SERVICE BULLETIN

Service Bulletin No.: DAC1-32-03 Rev 0

Title: NLG Wheel and Fork Installation
Improvements

Figure 1 - NLG Fork Assembly Installation

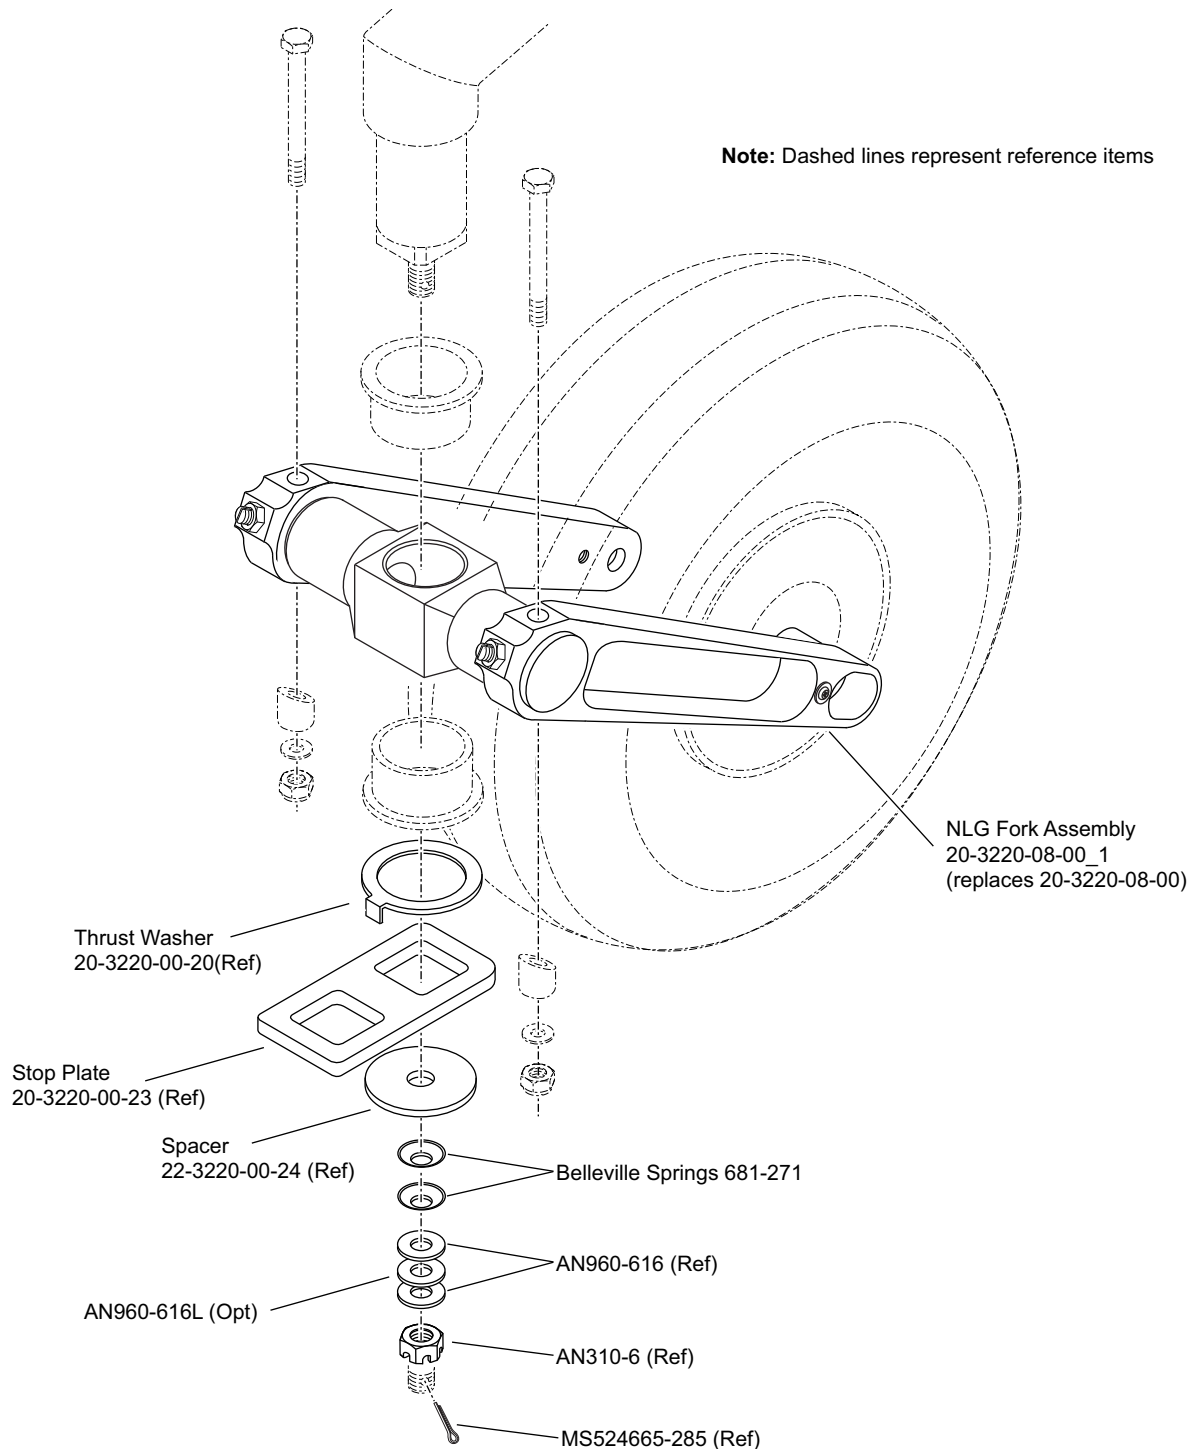
- 10.1** Either jack the aircraft in accordance with DA20-C1 AMM Chapter 07-10-00 or raise the front of the aircraft in accordance with Chapter 32-40-00 3.B. (page 203).
- 10.2** Remove the wheel in accordance with AMM Chapter 32-40-00
- 10.3** Remove NLG fork (A new fork assembly is available see SIL20C1-005) .
- 10.4** Inspect all parts for condition checking for cracks, corrosion and wear. New hardware should be used where necessary (For the fork assembly please review SIL20C1-005).
- 10.5** Apply CRC Corrosion Shell to the stud. Do not contaminate the tire or fiberglass.
- 10.6** Lubricate the axle in accordance with AMM Chapter 12-20-00.
- 10.7** Re install the fork using the new Belleville springs with the rest of the parts listed in figure 1. Be sure that both springs are installed with the open side facing up as per figure 1.

Figure 2 - NLG Wheel Installation with Shims

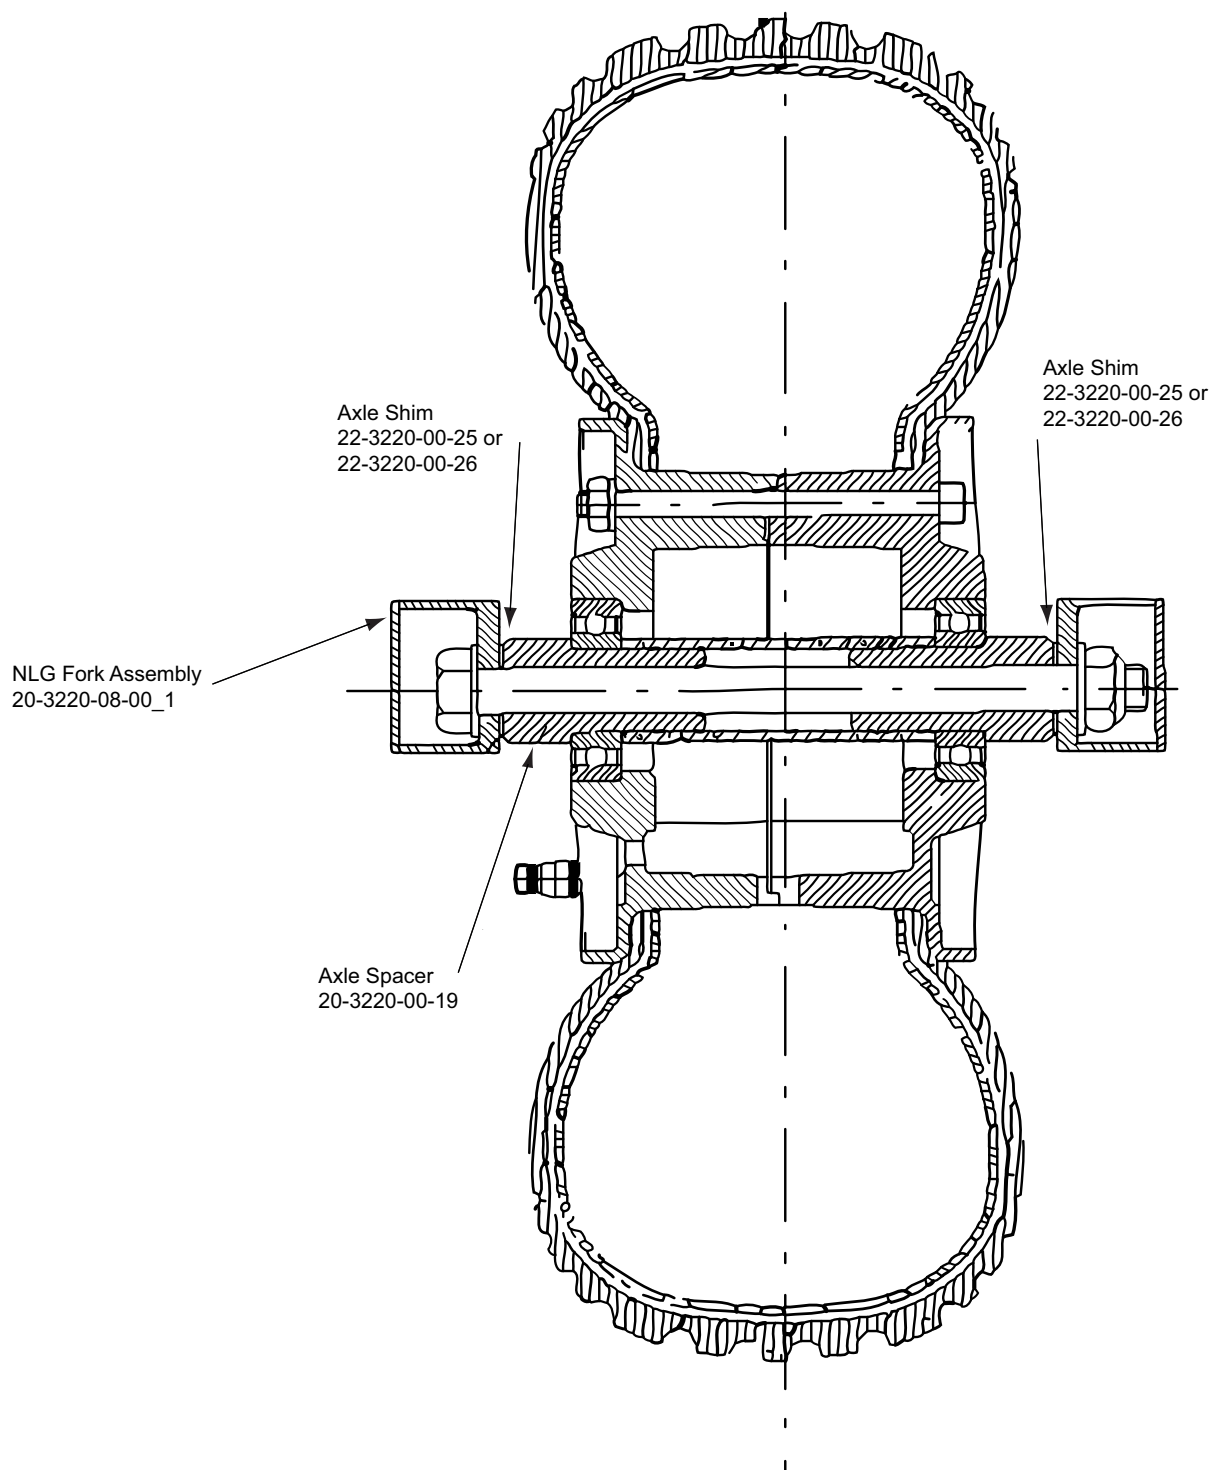
Note: The AN960-616L steel washer should be used if it is not possible to install the cotter pin correctly when adjusting the friction force.
- 10.8** Re install the wheel and use the shims to eliminate the gap between the axle spacer (20-3220-00-19) and the fork. Use a maximum of two shims and divide the shim installation evenly from side to side. Maximum difference between sides is 0.010". See figure 2.
- 10.9** Carry out friction adjustment as per AMM Chapter 32-20-00. Use the AN960-616L washer as noted above if required to properly install the fork and obtain the proper friction.
- 10.10** Make a log book entry that this Service Bulletin has been incorporated.
